THE GARDENS AT NORTH CAREFREE CONSTRUCTION DRAWINGS EL PASO COUNTY, STATE OF COLORADO

| GARDENS AT NORTH CAREFREE TITLE SHEET | |

| Sheet Subset: | | SHEET 26 OF 34 |

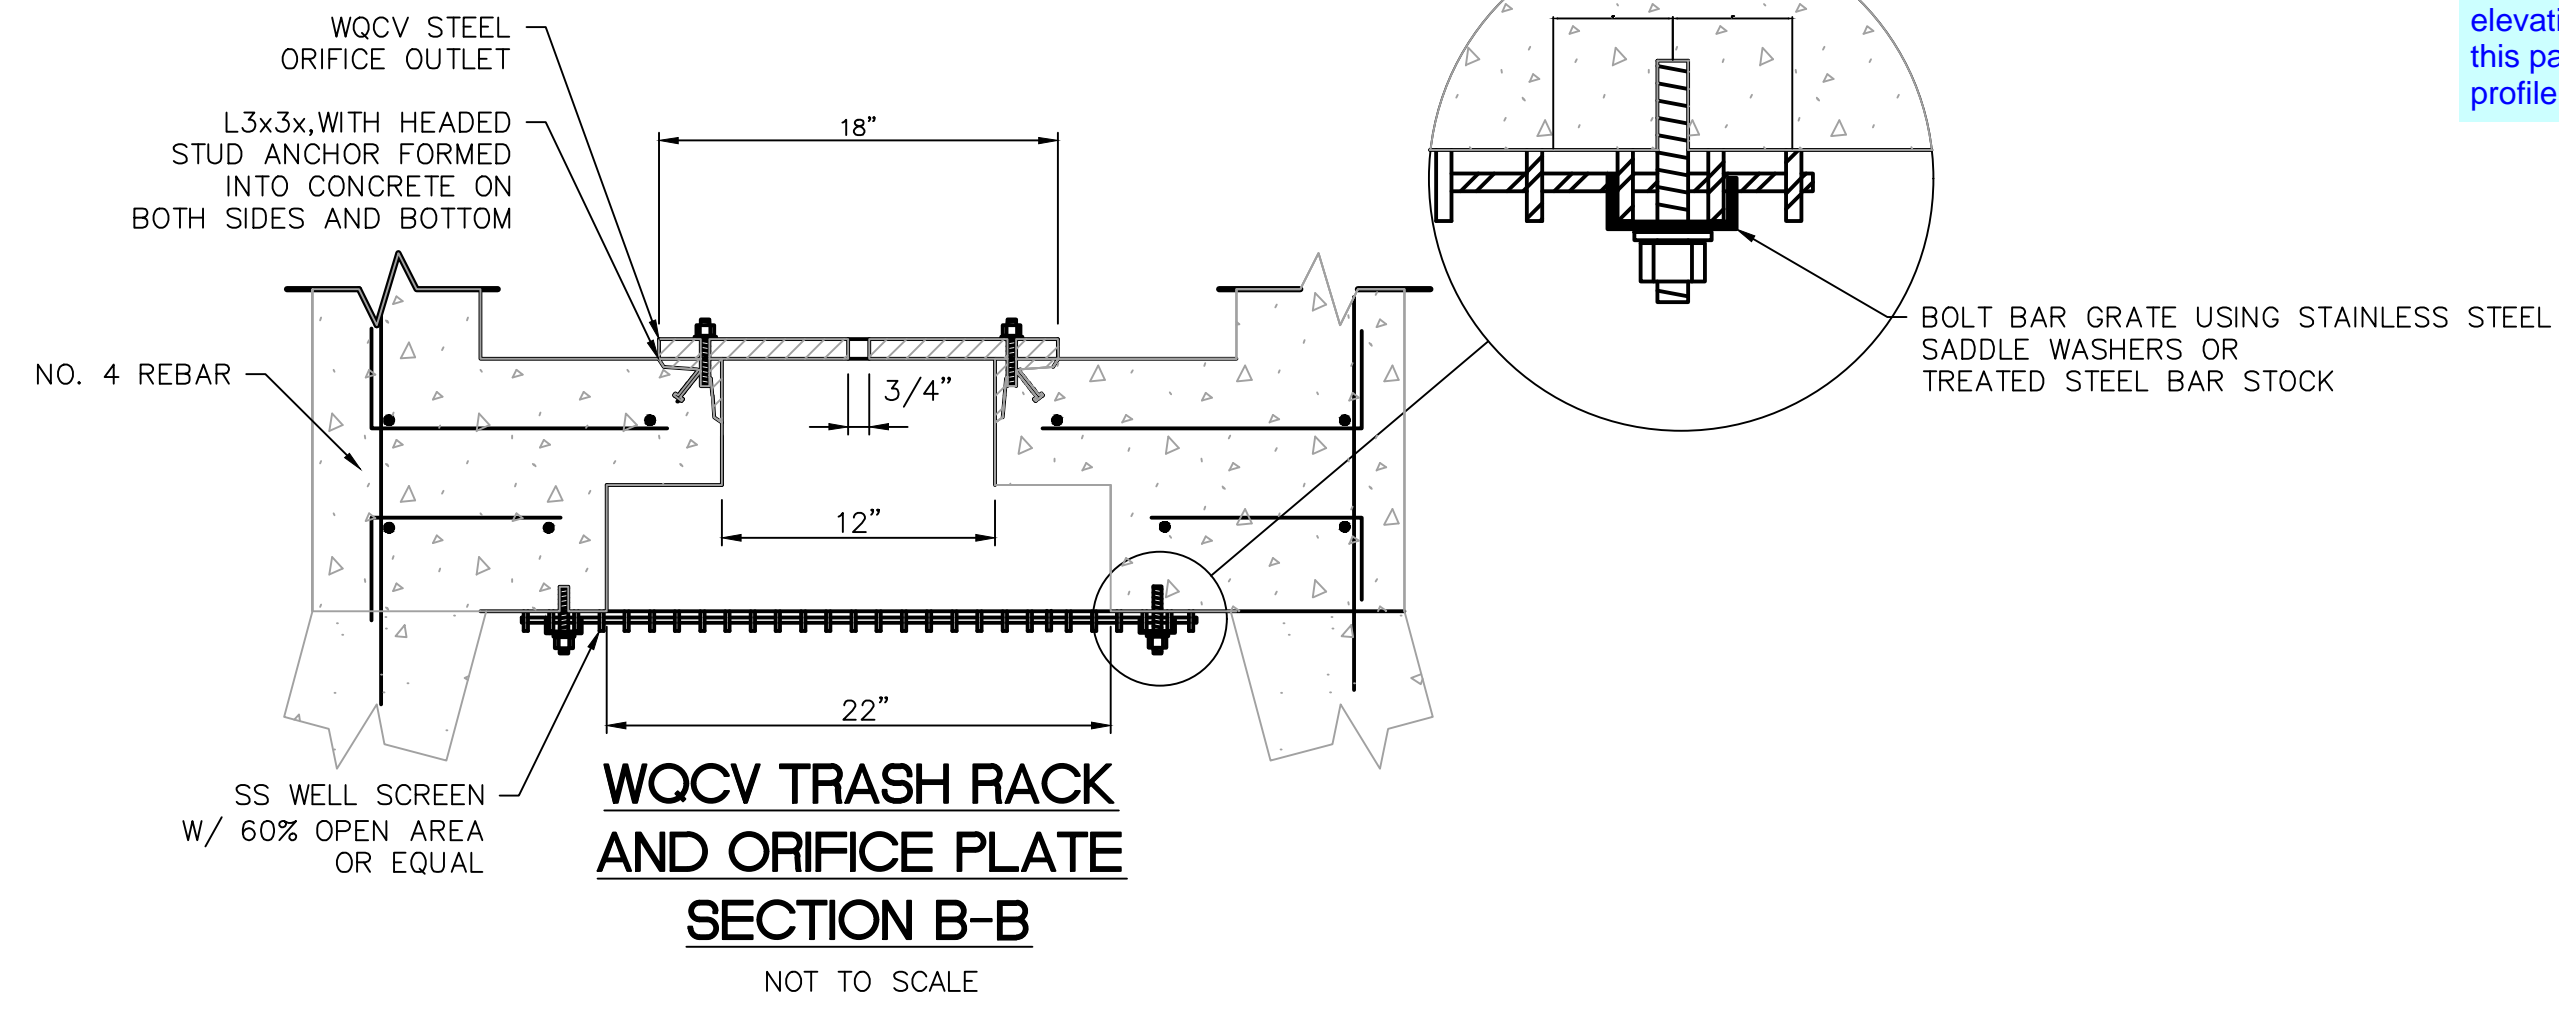
Ensure that all the elevations shown on this page and the profile are matching.

Provide type C inlet detail on the plans

Does not match the design calculation. Revise.

The micropool shall be a minimum of 2.5 ft in depth. Revise elevations accordingly so that they match the design calculations

| THE GARDENS AT NORTH CAREFREE GRADING & EROSION CONTROL PLAN | |

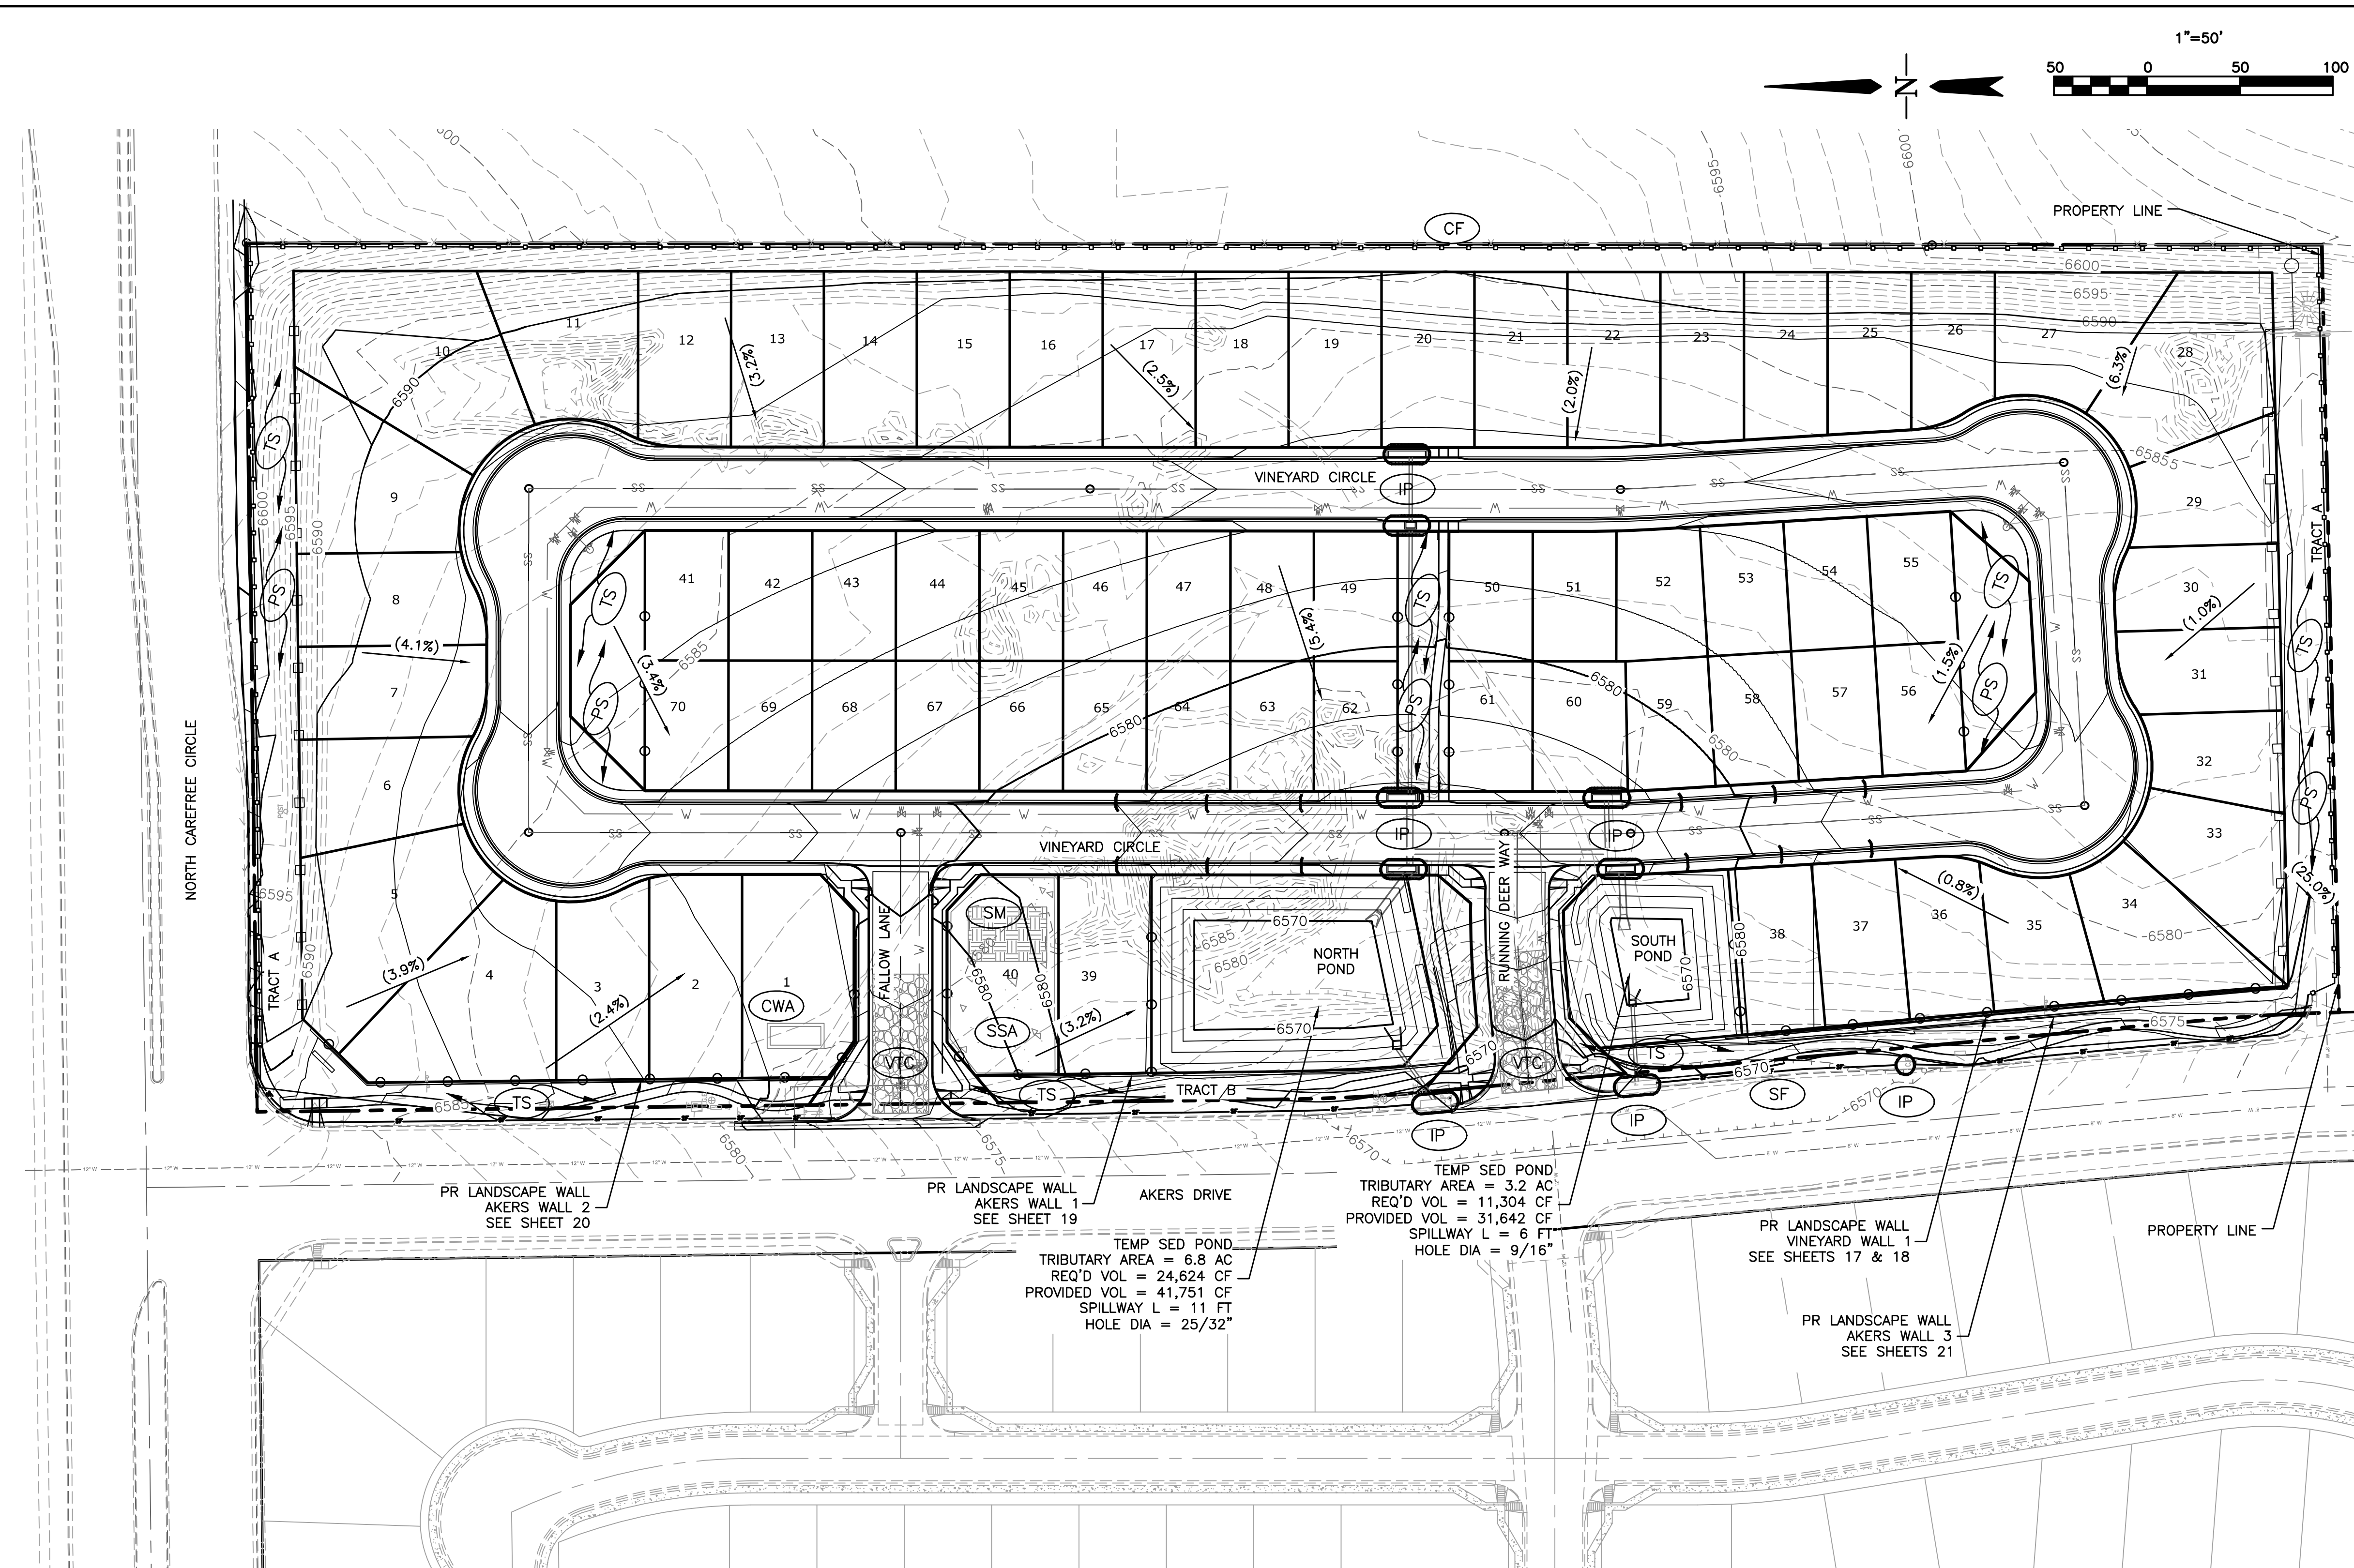
See comments on stand alone GEC plan.
